Access Compliance Report Public Rights-of-Way (Curb Ramps)

Intersection ID: 2910Main Street:RIDGEFIELD_DRCross Street:SWANSTON_DRLocation:NWADA ID: 1DB6F88C388BRamp Type:PerpDiagInitial Pass/Fail:FailOverall Compliance:NoSeverity Score:10

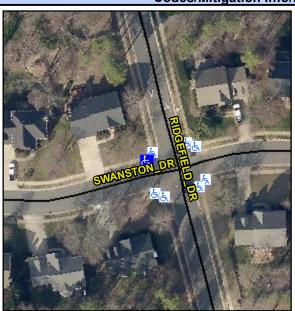
Not Found, R304.5.1, R304.5.3

Field Measurements/Component Compliance					
Compliance Description		Data	Compliance Description		Data
N/A	Ramp Length (in)	48.0	Yes	Ramp Slope (%)	6.6
No	Ramp Width (in)	38.0	No	Ramp XSlope (%)	3.0
N/A	Flare Type LT	N/A	N/A	Flare Type RT	N/A
N/A	Flare Slope LT (%)	N/A	N/A	Flare Slope RT (%)	N/A
N/A	Flare Traversable LT?	N/A	N/A	Flare Traversable RT?	N/A
N/A	Landing Length (in)	N/A	N/A	DWS Provided?	N/A
N/A	Landing Width (in)	N/A	N/A	DWS Contrast?	N/A
N/A	Landing Slope (%)	N/A	N/A	DWS Length (in)	N/A
N/A	Landing X Slope (%)	N/A	N/A	DWS Full Width?	N/A
N/A	Landing Curb? (Y/N)	N/A	N/A	DWS Offset (in)	N/A
N/A	Shared Landing?	N/A			
N/A	Gutter Ponding?	N/A	N/A	Gutter Slope (%)	N/A
N/A	Gutter Lip Ht (in)	N/A	N/A	Gutter X Slope (%)	N/A
N/A	Painted X Walk1?	No	N/A	Painted X Walk2?	No
	X Walk 1 Direction	To S		X Walk 2 Direction	To E
N/A	X Walk 1 Width (in)	N/A	N/A	X Walk 2 Width (in)	N/A
	X Walk 1 Slope (%)	1.3		X Walk 2 Slope (%)	1.3

Remove & Replace Curb Ramp With Two New Directional Ramps or Equivalent.
